<b>Title - Sujet</b> Upscheek Tashee Trail Construction	
<b>Solicitation No. - N° de l'invitation</b> 5P437-190013/B	<b>Amendment No. - N° modif.</b> 003
<b>Client Reference No. - N° de référence du client</b> 5P437-190013	<b>Date</b> 2019-03-26
<b>GETS Reference No. - N° de référence de SEAG</b> PW-\$PWY-019-8566	
<b>File No. - N° de dossier</b> PWY-8-41204 (019)	<b>CCC No./N° CCC - FMS No./N° VME</b>
<b>Solicitation Closes - L'invitation prend fin</b> <b>at - à 02:00 PM</b> <b>on - le 2019-04-18</b>	<b>Time Zone</b> <b>Fuseau horaire</b> Pacific Daylight Saving Time PDT
<b>F.O.B. - F.A.B.</b> <b>Plant-Usine:</b> <input type="checkbox"/> <b>Destination:</b> <input checked="" type="checkbox"/> <b>Other-Autre:</b> <input type="checkbox"/>	
<b>Address Enquiries to: - Adresser toutes questions à:</b> Ngan, Ken (PWY)	<b>Buyer Id - Id de l'acheteur</b> pwy019
<b>Telephone No. - N° de téléphone</b> (604) 671-0219 ( )	<b>FAX No. - N° de FAX</b> (604) 775-6633

This Solicitation Amendment 003 is raised to incorporate Addendum 3, and the associated revised Unit Price Table, Environmental Procedures, and Drawings.

**Ups-cheek Ta-shee**  
**Pacific Rim National Park Reserve, British Columbia

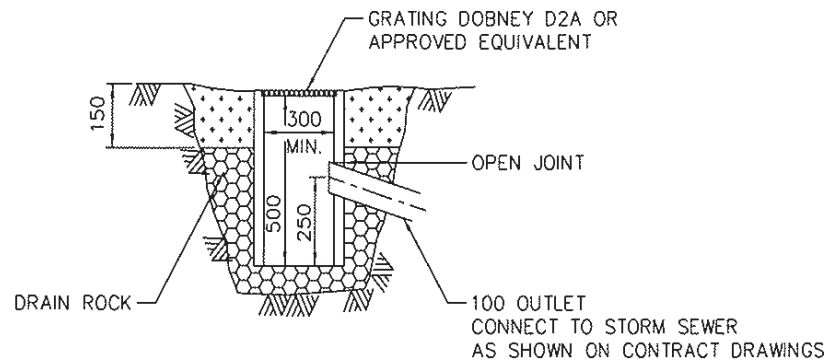
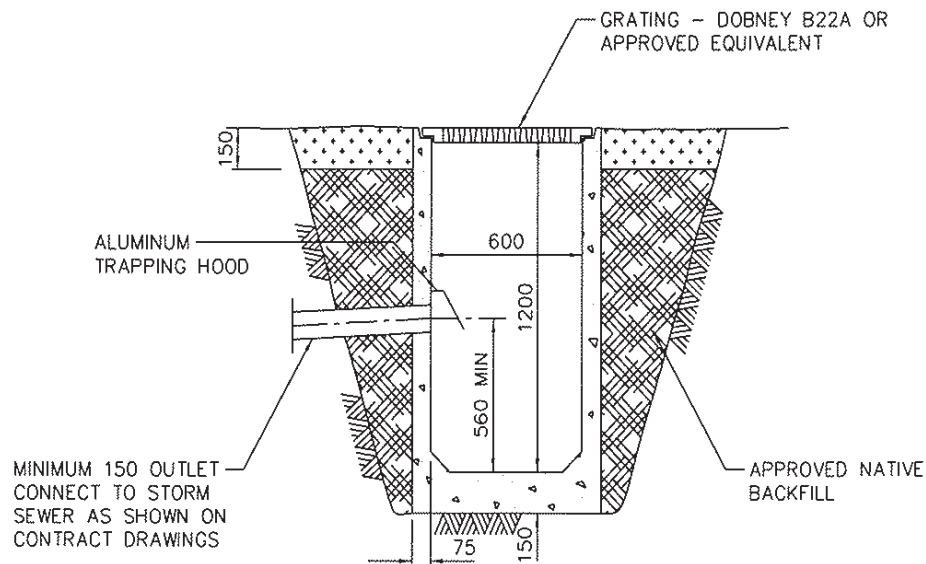
**16. Question:** Please provide a detail for the forestry gates trail.

**Answer:** Pay Items 52 (8m wide parking lot gate) and item 53 (5 m wide access gate) are for the supply and installation of each size of metal gate. Specification 05 51 00, clause 2.1.7 provides a generic description of the gates and the minimum dimensions of the steel components. A typical swing gate design is included in this addendum. Alternate designs providing similar security and durability are acceptable.

LAWN DRAINS

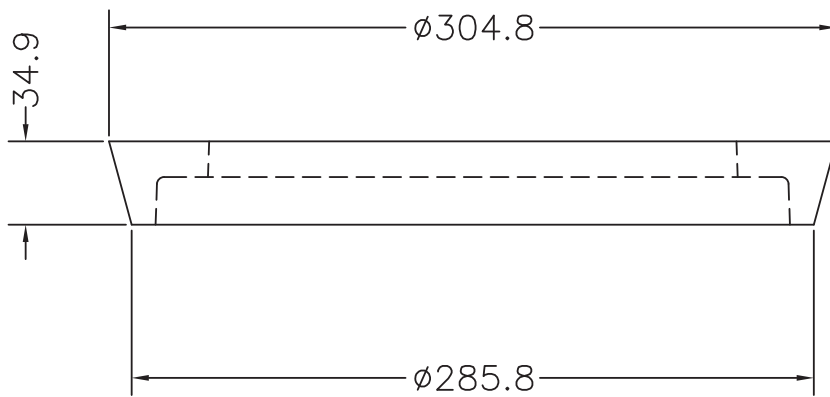
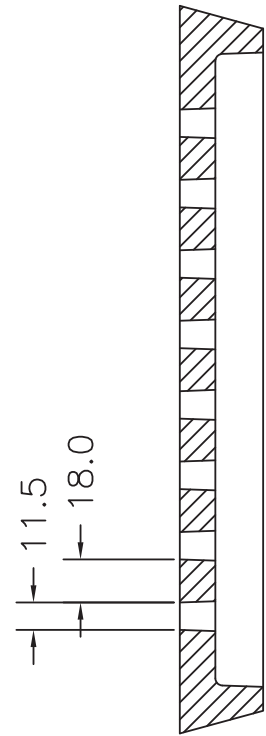
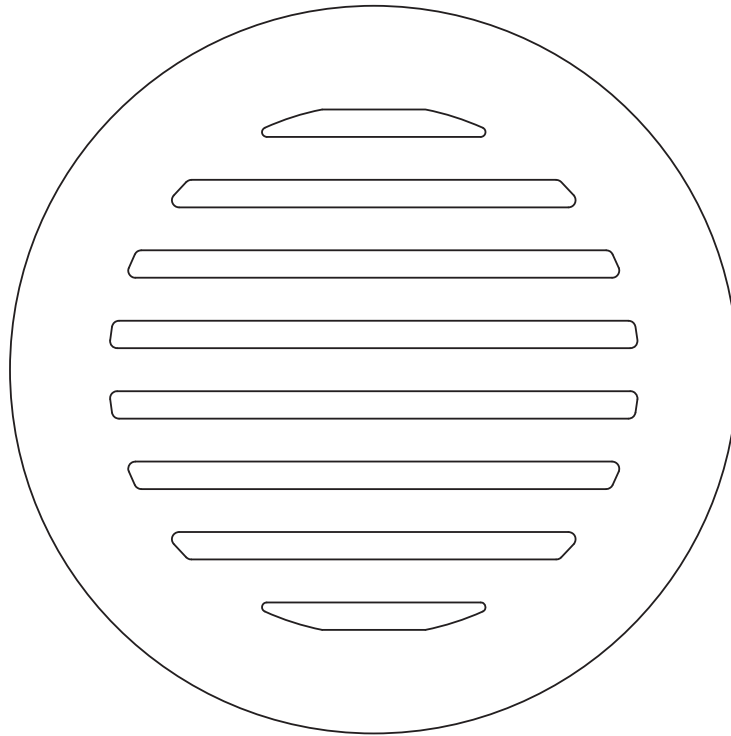
1. **Question:** For pay item #192, 200mm diam. lawn basin grate inlet, please provide locations, detail and specifications for lawn basin grate inlet.
-

**Answer:** Pay item 192 is revised to 300mm diameter lawn basin as detailed in Master Municipal Construction Documents (2009) Drawing Number S12, Type 1 lawn basin, and Dabney Foundry grate D-2, drawing no. D-2. Both drawings included in this addendum. Lawn basins will be placed at the low points of the swales at the retaining wall locations detailed in the “W” series of the contract drawings and connected into the wall drainage system. The low point shall be determined at time of construction to ensure the actual low point is drained.
